**Figure 1:**

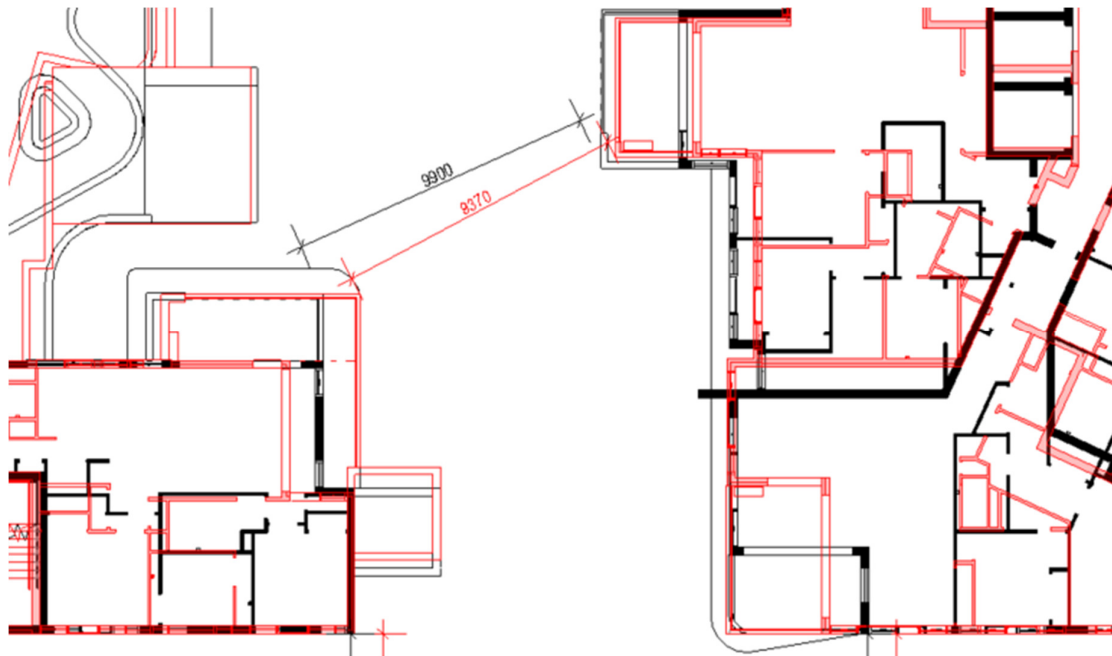
Unit 37 & Unit 50 separation has increased from 9.37m (approved DA in red) to 9.9m (S4.55 in black).

**Figure 2b:**

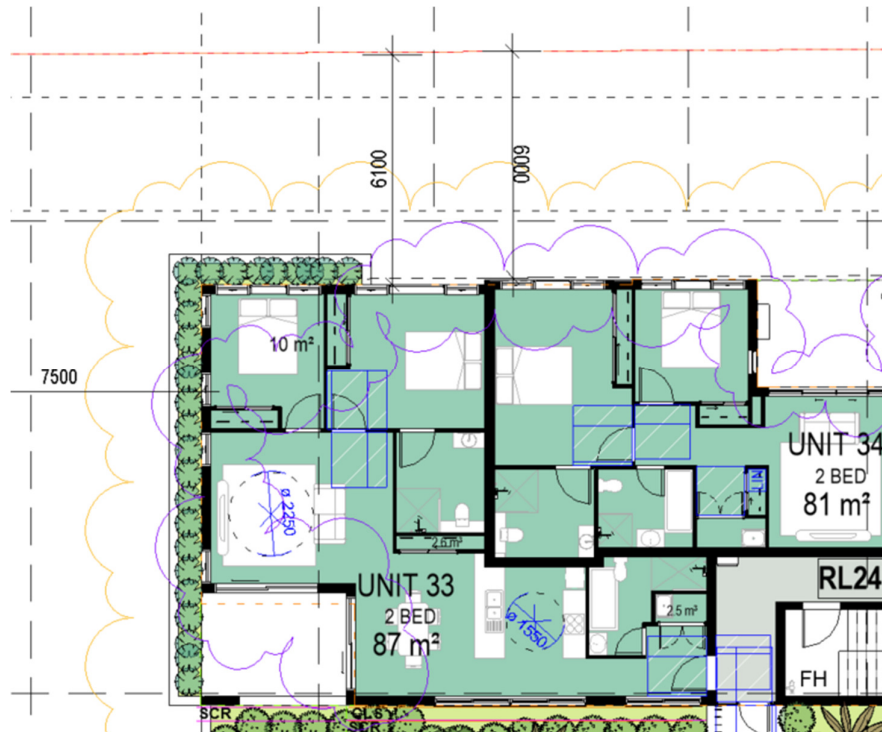
Planter in S4.55 wraps around the corner to soften the building appearance.

Approved DA in red, S4.55 in black.

**Figure 3:**

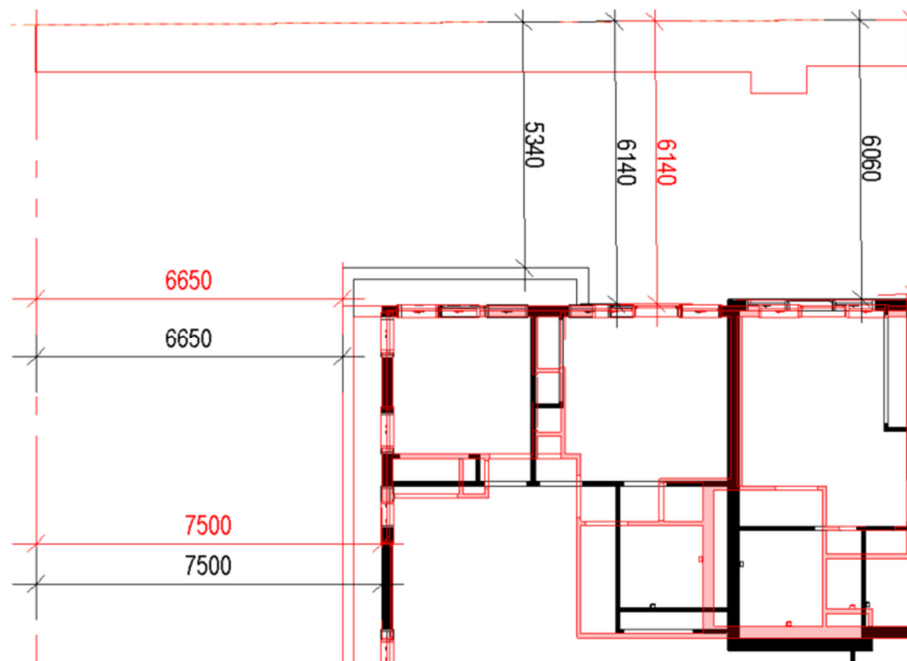
Other units on the 6m setback. Planter encroaches 6m setback.

**Figure 4:**

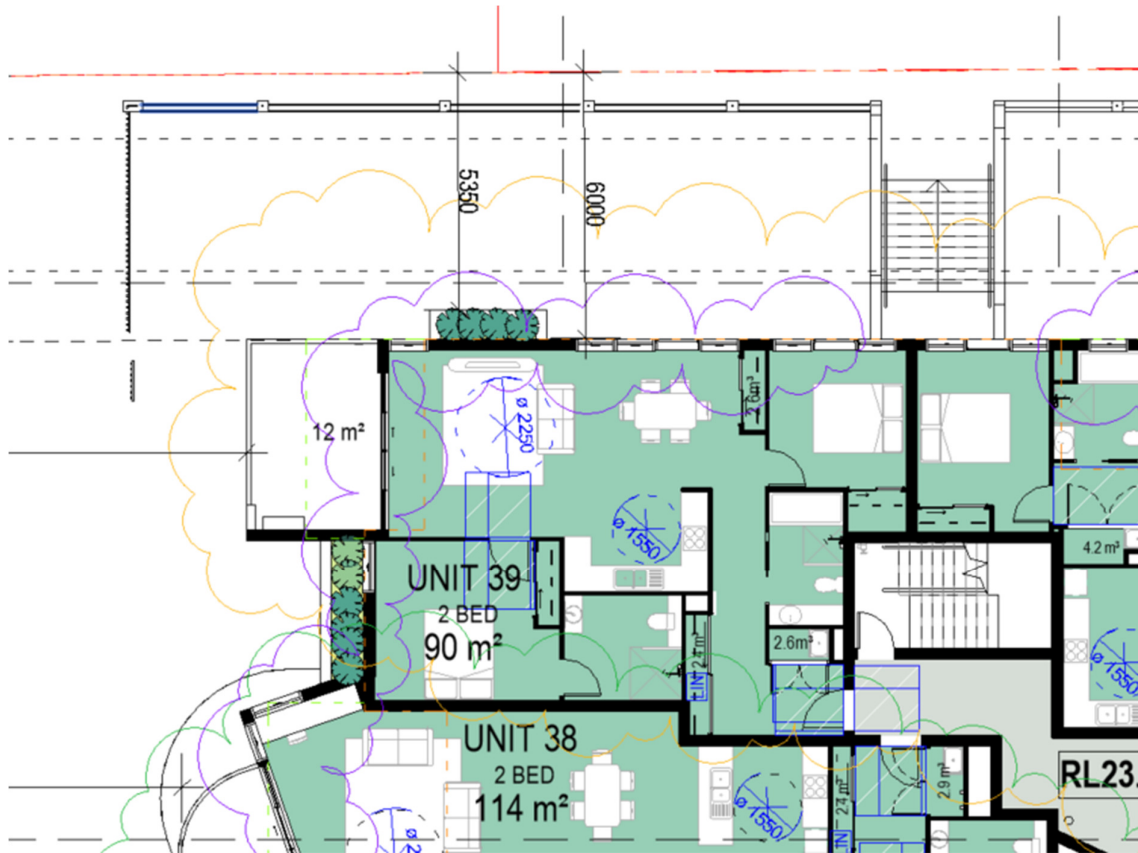
Unit 55 with balcony of 13 m².

Figure 6 a & b:

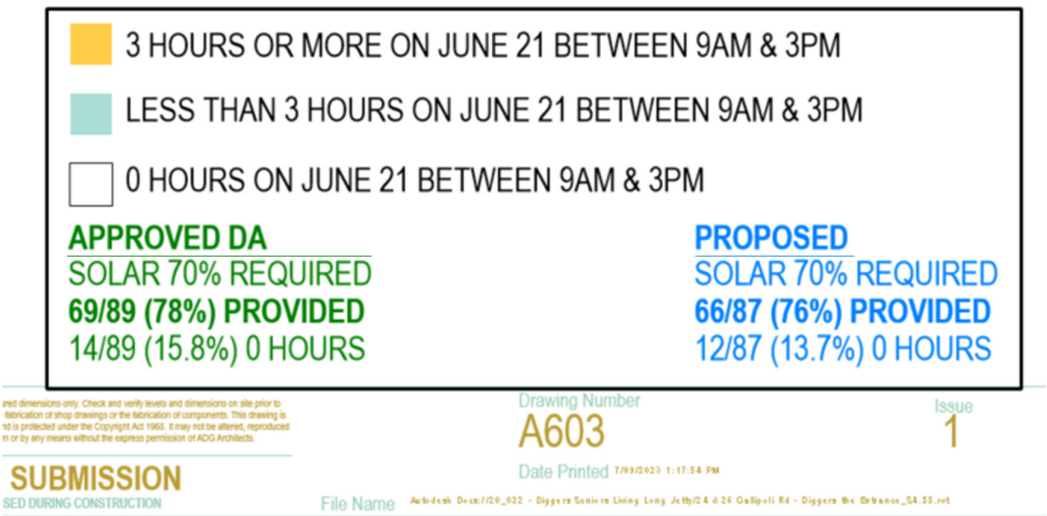
Shower located before bath as a wet area beyond. Point of difference in the design.

**Figure 8:**

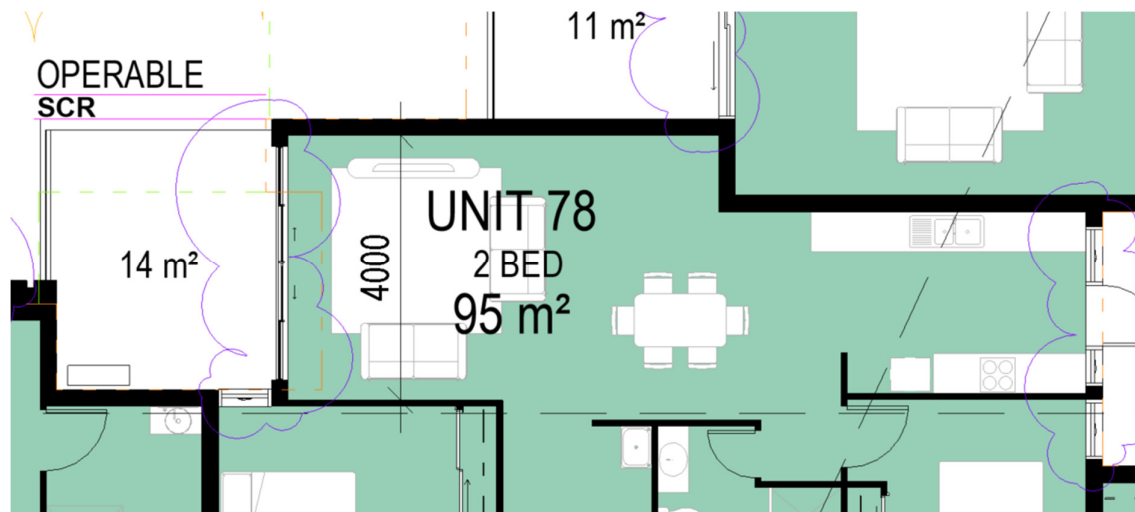
Layout updated to get access to a full height storage, and not just space above desk level.

Figure 9:

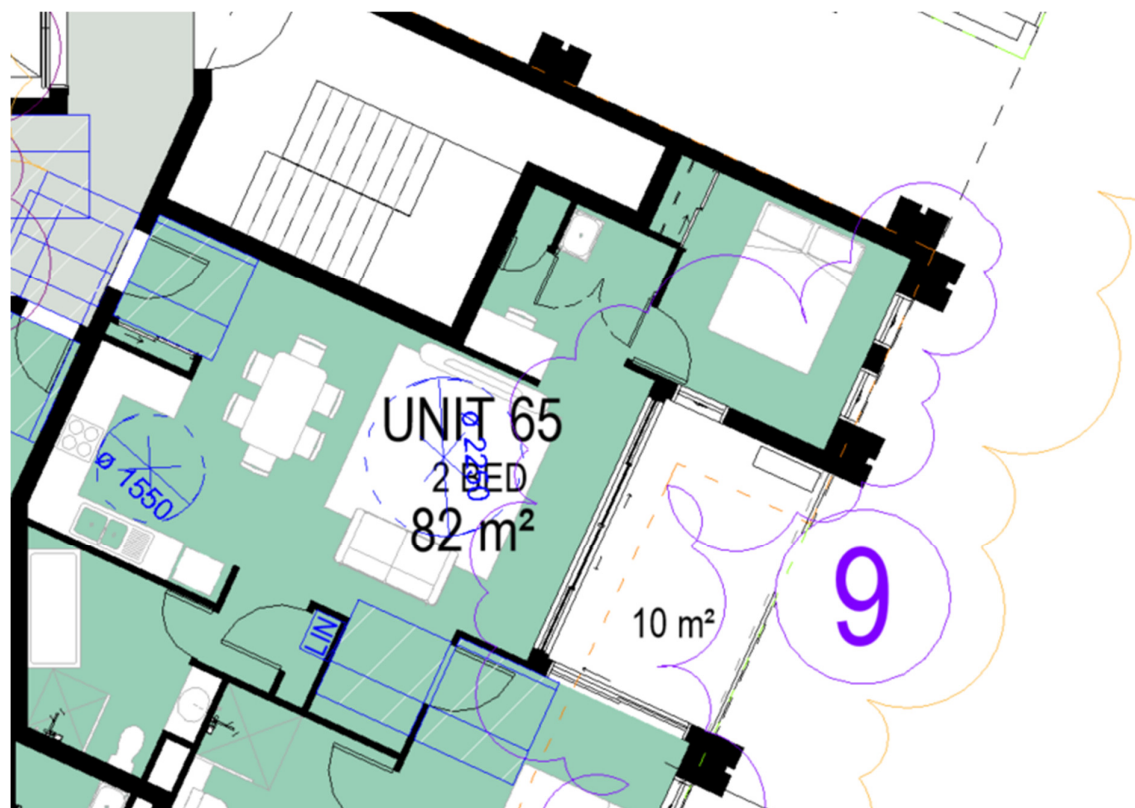
Layout updated to include robe.
